FED. ROAD DIST. NO.	STATE	FED. AID PROJ. NO.	FISCAL YEAR	SHEET NO.	TOTAL SHEETS
HAWAII	HAW.	360A-01-90M	1990	ADD.3	5

DRAINAGE PLAN
HANA HIGHWAY
WAIKANI BRIDGE REPAIR
PROJ. No. 360A-01-90M

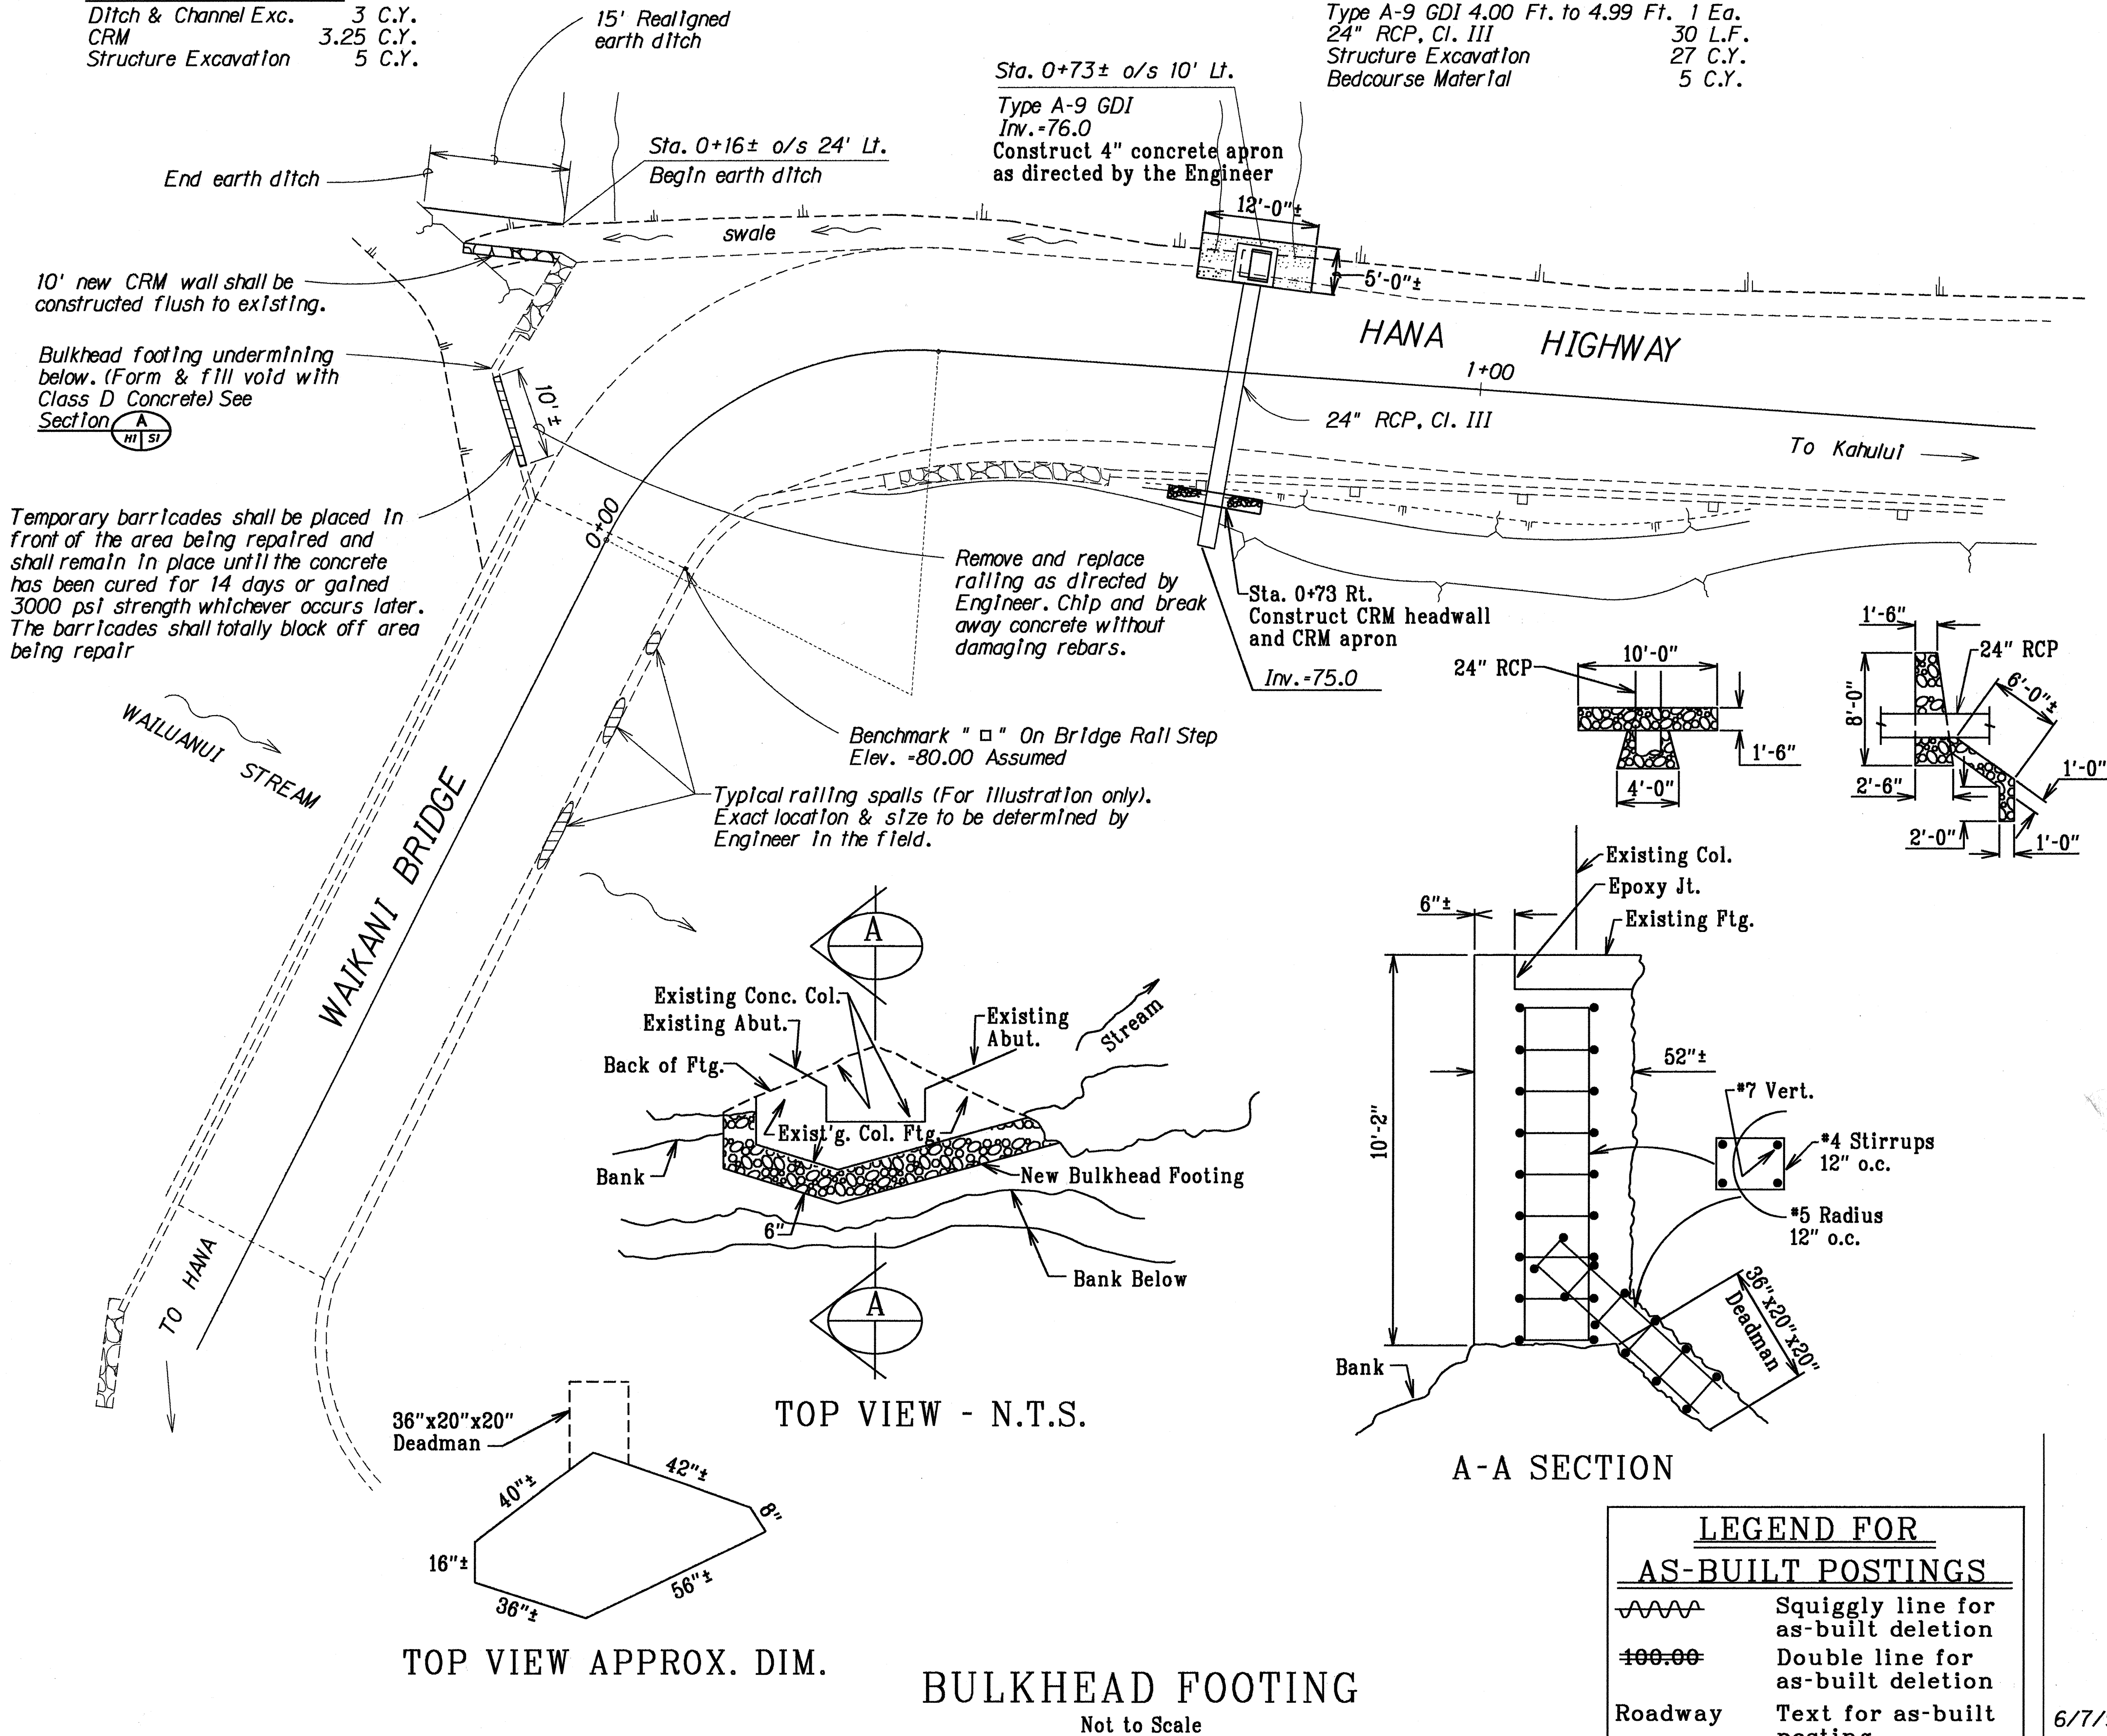
6/7/90	Added Assumed Benchmark Note
DATE	REVISION
